Product Discontinuation Notice

No.ICDRY-080040

Solid State Relays (Single-phase) G3PB series

Solid State Contactors (Three-phase) G3PB-2(N)/-3(N) series

(Relevant model : G3PB-215B/225B/515B/-VD)

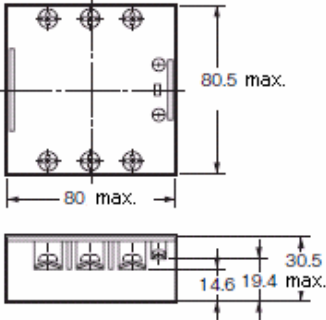
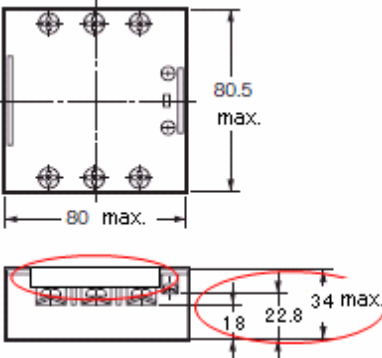
Product discontinuation	Recommended replacement
	<p>Note : The change of terminal cover to improve finger protection.</p>

(Relevant model : G3PB-2□□B-2(H)(N)-VD、G3PB-2□□B-3(H)(N)-VD、
G3PB-4□□B-2(H)-VD、G3PB-4□□B-3(H)-VD
G3PB-5□□B-2(H)(N)-VD and G3PB-5□□B-3(H)(N)-VD)

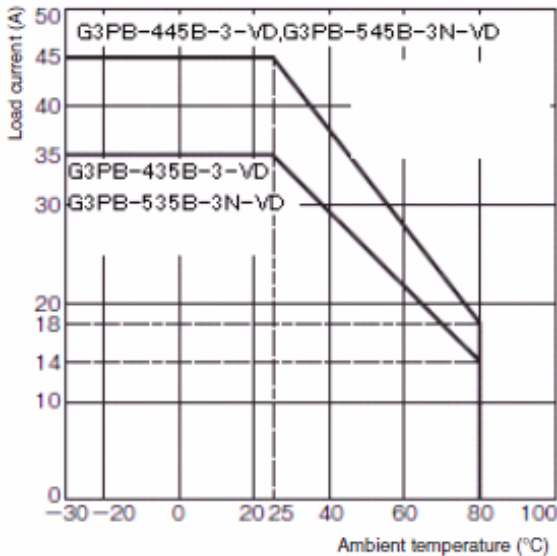
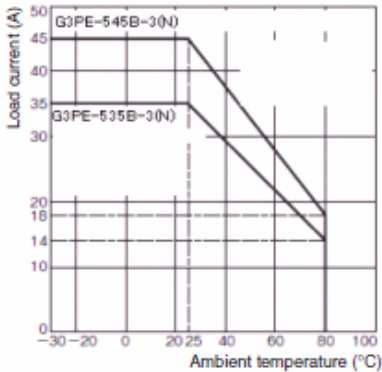
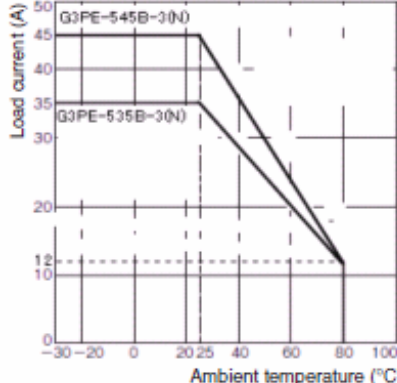
Product discontinuation	Recommended replacement
	 <p>Note 1) The change of terminal cover to improve finger protection. 2) Height change</p>
<div style="border: 1px solid black; padding: 5px; display: inline-block;">Size of heat-sink is the same</div>
